MEMORANDUM

Re: Hydrologic Closure for the Buckhorn Mine

Date: October 3, 2016

3. Comments on Attachment A: Golder Technical Memorandum: Hydrologic Closure Plan

NWF-1/NLF-3 Fault Zone Groundwater (Section 2.2.2.4)

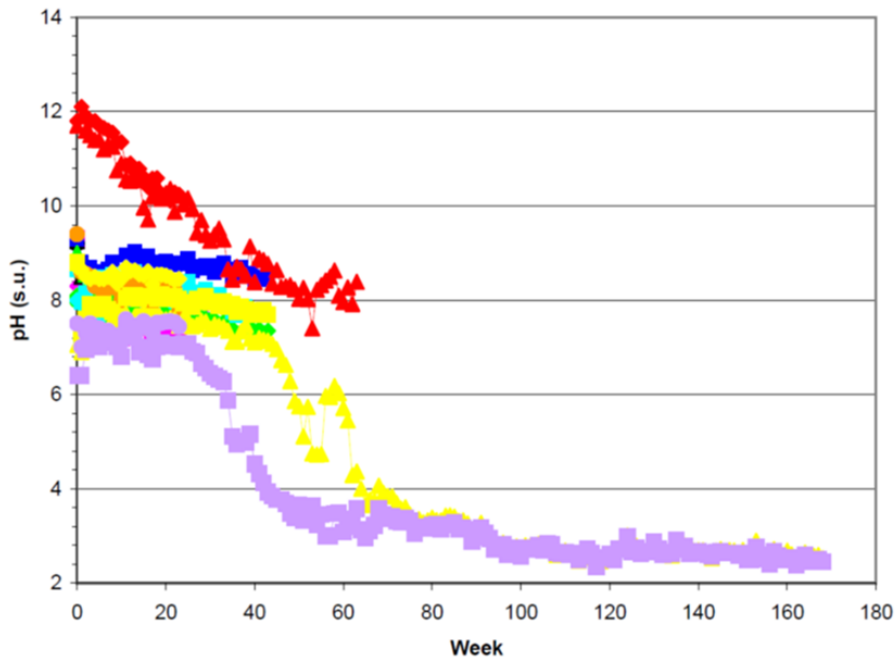
This section states that pump testing of MW-17, which was installed in 2013, is being conducted to better understand groundwater flow in the area. The MW-17 pump test has been underway for over a year. Crown/Golder may not have concluded testing, but MW-17 monitoring data should be included in Appendix E or F; water quality data have not been made publically available since November 2014. Since the pump test began, contaminant concentrations in some of the nearby wells have decreased, suggesting that strategic placement of dewatering wells in the faults could help attain compliance. In addition, piezometers in this area should be converted to water quality monitoring points to increase the understanding of contaminant flow paths.
